From: [REDACTED]
To: [REDACTED]
CC: [REDACTED]
Sent: 3/23/2021 4:13:07 PM
Subject: RE: O8W-PM [REDACTED] Bucks Creek 1101 Phase 1,2&3 -
Pre-Engineering Meeting

Subject: O8W-PM [REDACTED] - Bucks Creek 1101 Phase 1,2&3 - Pre-Engineering Meeting

PM [REDACTED] (Phase 1)

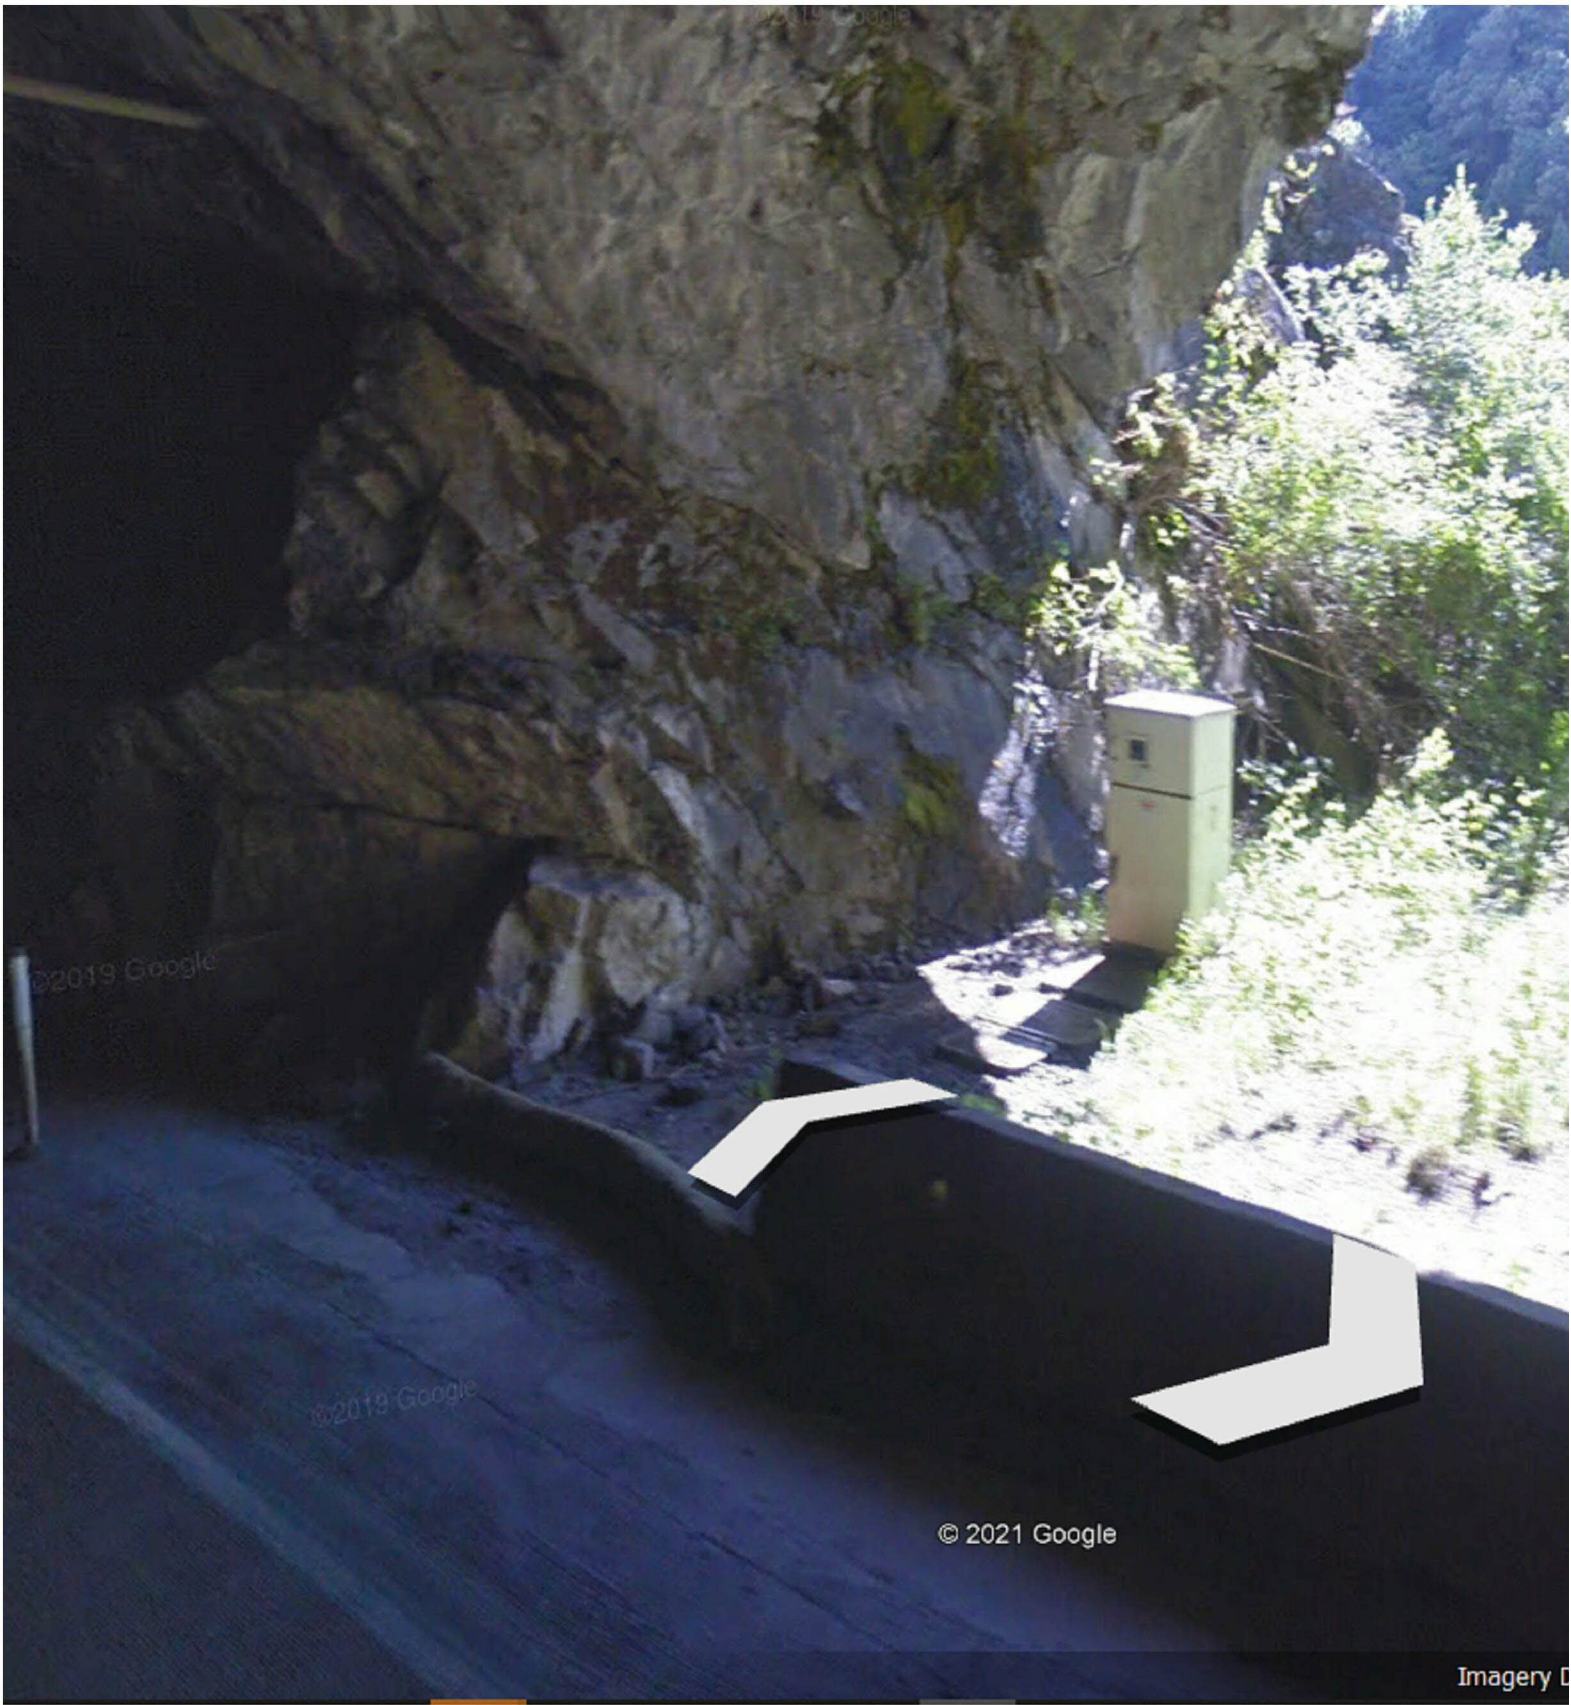
Attached are the 'base-map' limits in a kmz. file. As you will see, we need our base-map to go about ~100' into the tunnel at the south end (see pedestal in picture below....please begin about ~50 beyond this point which is about ~100' beyond the Cresta Dam).

We want to end the base-map at the sign location below which is roughly at MM (Mile Marker) 5.10.

Bucks Creek 1101- PM# [REDACTED] Overview Map

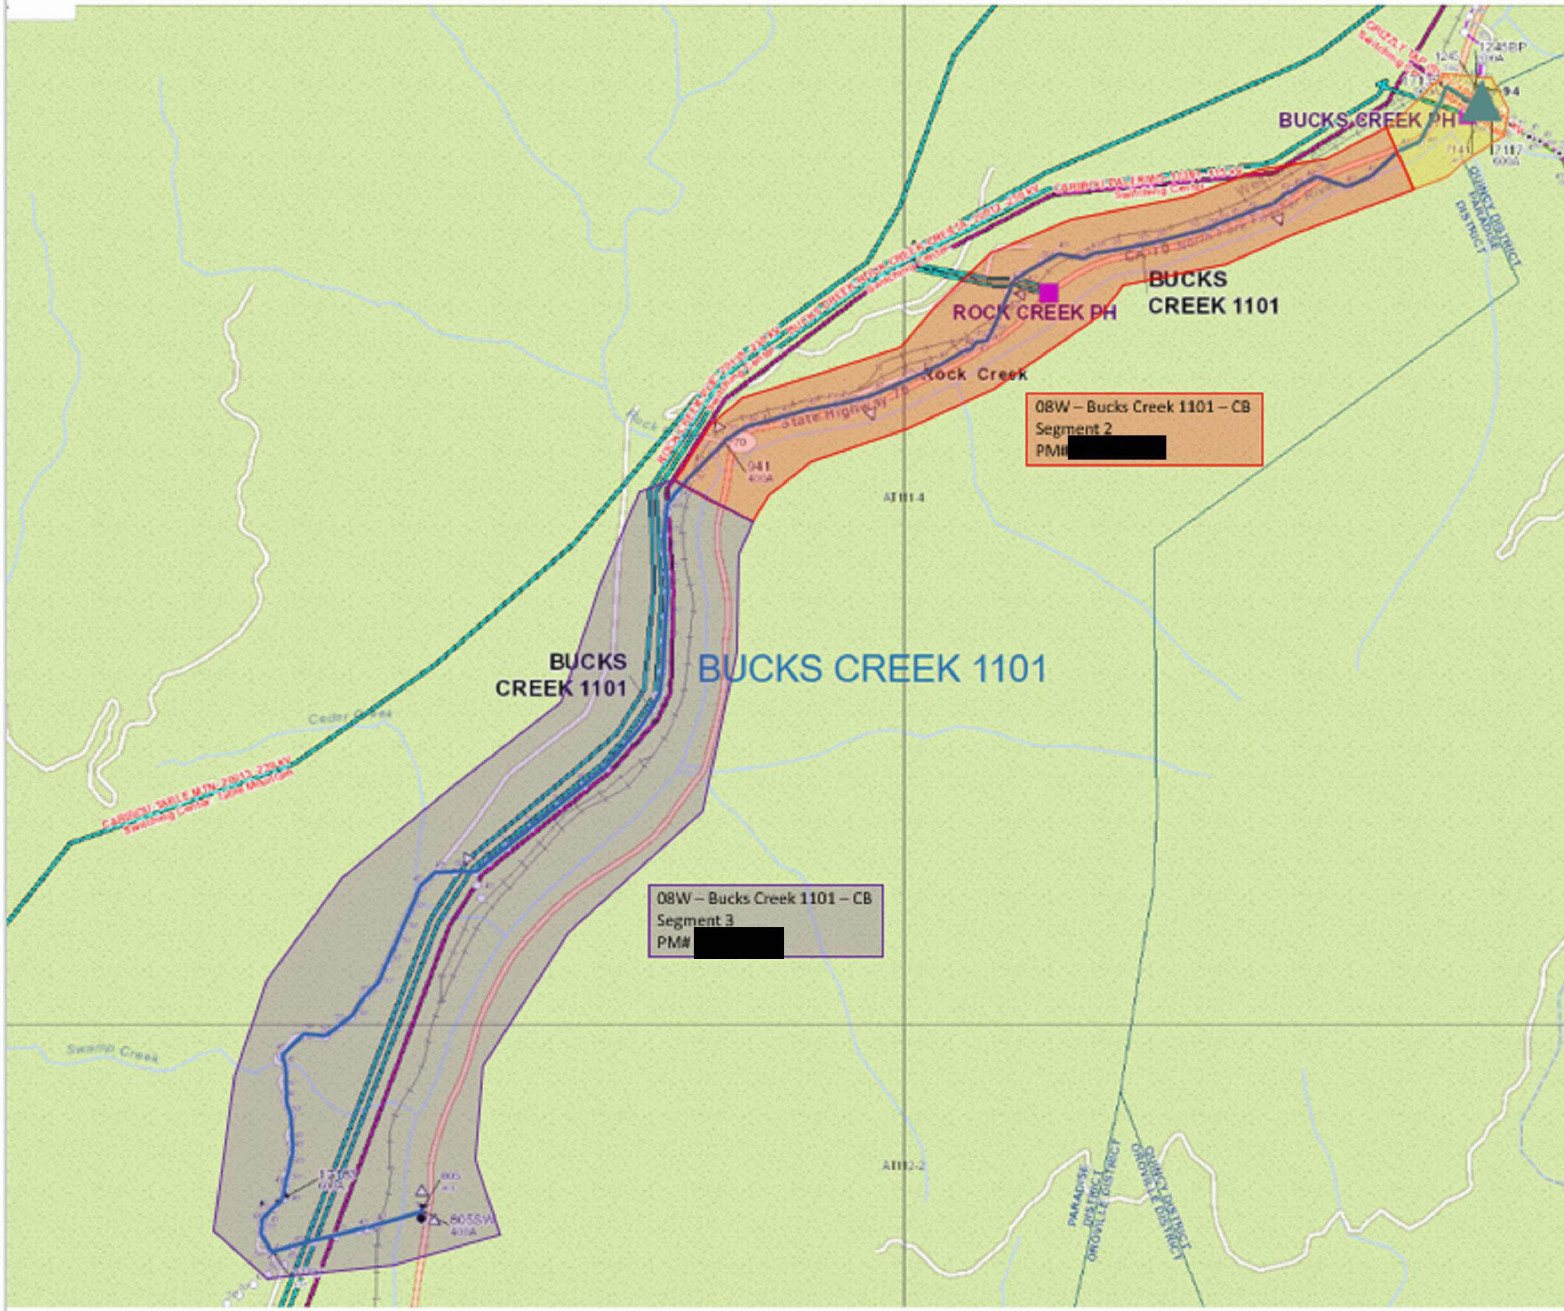
For Bucks Creek there is quite a bit of work surrounding Hwy 70 and we will need a Land Department Base Maps prepared for all 3 Orders. This will delay the EOD dates until these can be developed and provided to the Vendor... We will also need answers to the questions outlined by [REDACTED] below...
